**STATE OF CALIFORNIA
CALIFORNIA REGIONAL WATER QUALITY CONTROL BOARD
SAN FRANCISCO BAY REGION**

**STAFF SUMMARY REPORT
STAFF: VIC PAL
MEETING DATE: April 9, 2008**

SUBJECT: Cypress-Amloc Land Company, Hillside Class III Waste Disposal Site, Colma, San Mateo County – Adoption of Updated Waste Discharge Requirements and Rescission of Order No. 97-009

REVISED TENTATIVE ORDER

FIGURE 1
Examples of Groundwater Level Contour Maps Reported by Hillside Landfill

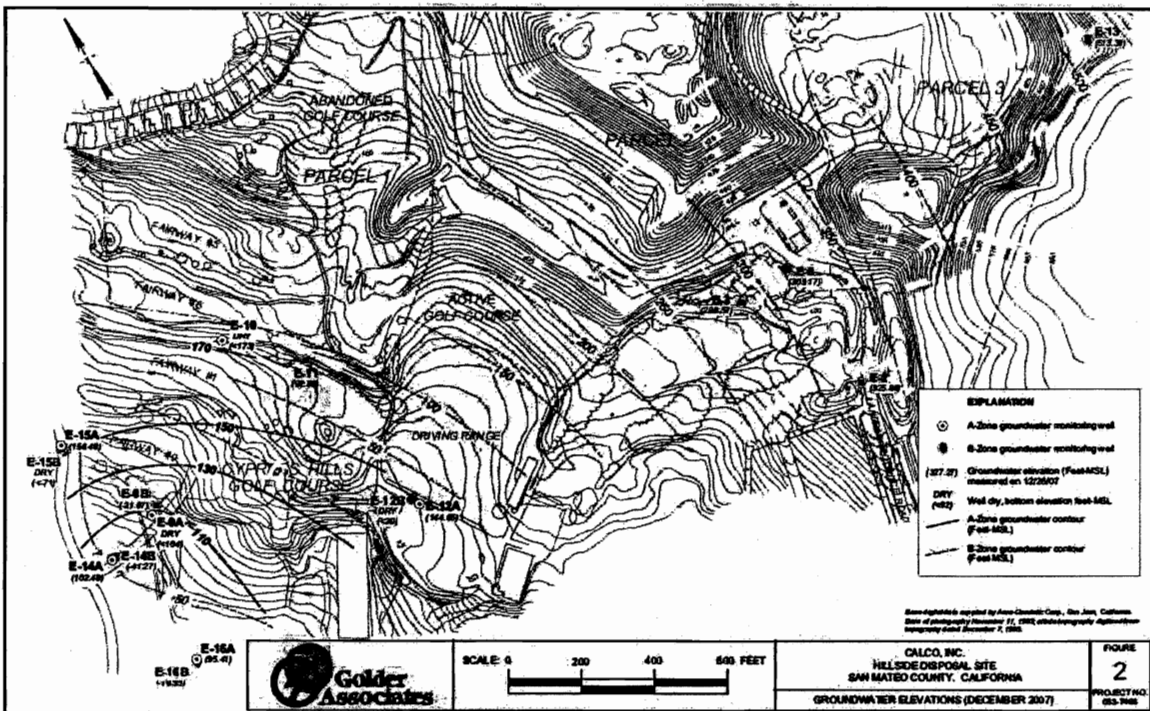
- (4) Groundwater flow has been reported by the Discharger, in past years, as moving from northeast to southwest in two layers (zones: A-zone and B-zone). More recently, with the inclusion of six new wells installed as part of a consent decree, the Discharger reports the groundwater moving to the south. (Refer to Figure 1)

1. Figure 1 is two examples of groundwater flow contour maps as reported by Hillside Landfill operators. Groundwater flow has been reported by the landfill operator, in past years, as moving from northeast to southwest in two layers (zones: A-zone and B-zone). More recently, with the inclusion of six new wells installed as part of a consent decree, the operator reports the groundwater moving to the south.

FIGURE 2

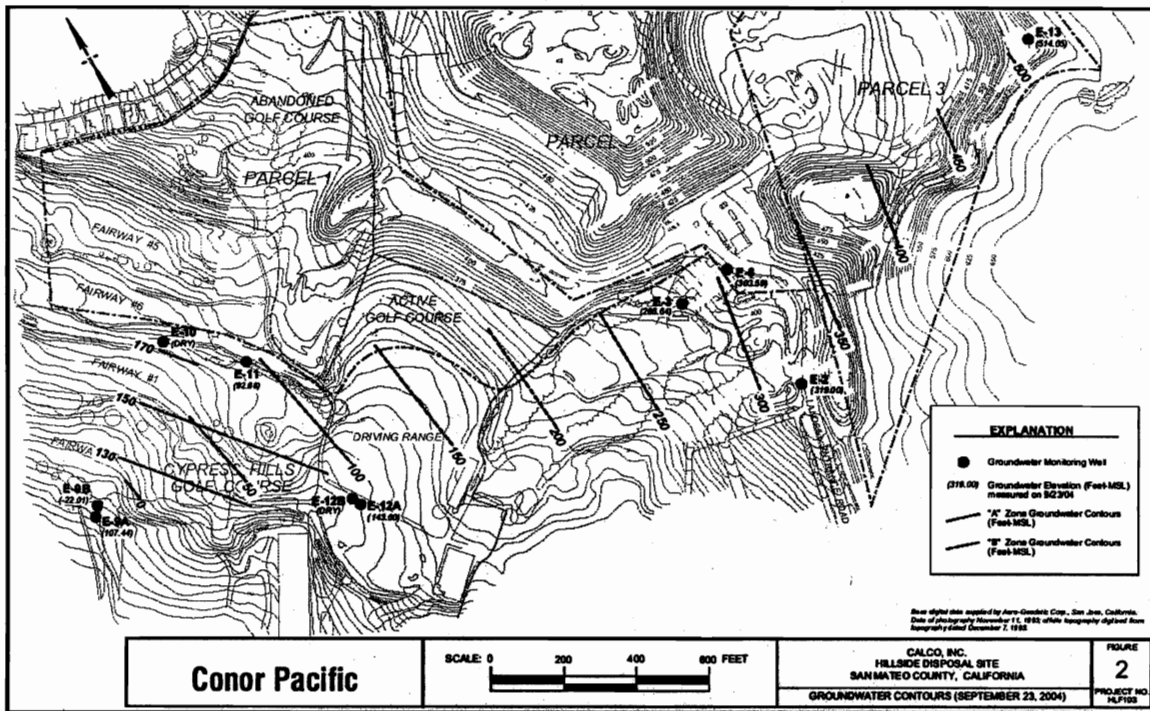
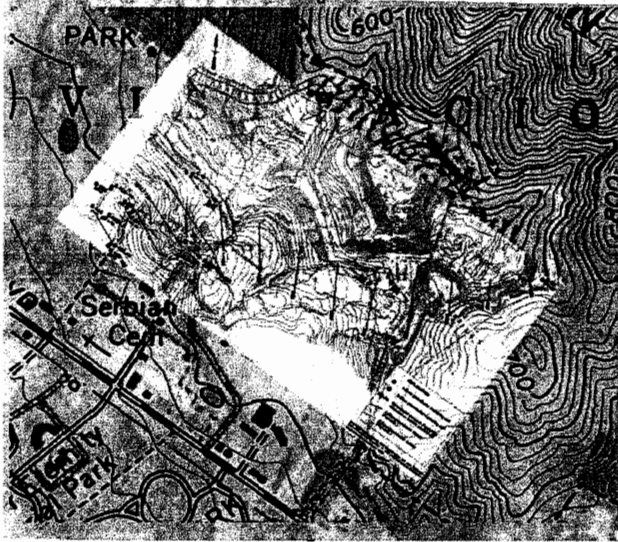
2. Figure 2,a, depicts the facility ground surface map overlaid atop an aerial photograph of the facility and region, Figure 2,b. shows the same facility map overlaid atop the USGS topographic map with 1956 elevation contours, and Figure 2,c shows the facility translucent atop the USGS map with the now buried valleys delineated in blue dashed lines. Even though the 1956 USGS maps have been incorporated into previous studies submitted by the Discharger, they have failed to note these features let alone address them.
